Special Bulletin

SP16-309A

CURB SIDE ENGINE DOOR FAN SECUREMENT

Prevost vehicles

Figure 1

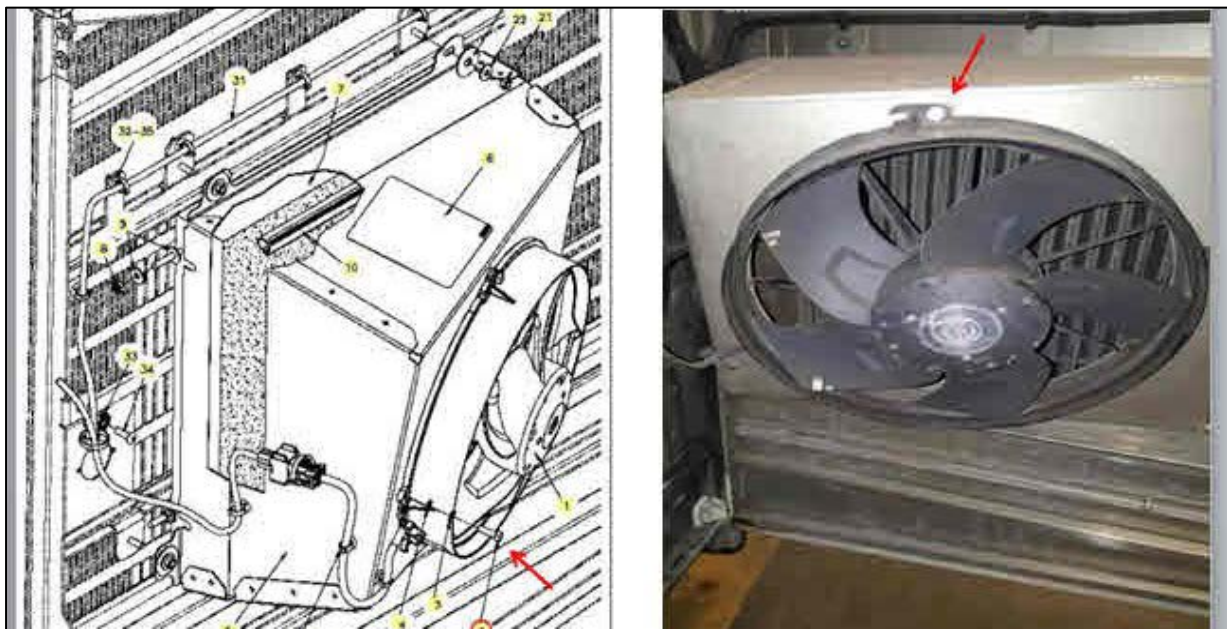
1. Locate the curb side engine compartment door.
2. Locate the fan on the door.

3. Remove fan mounting hardware (4x) one location at a time.
4. Apply Loctite 243 thread locker 685072.
5. Tighten to 7 lbf-ft.
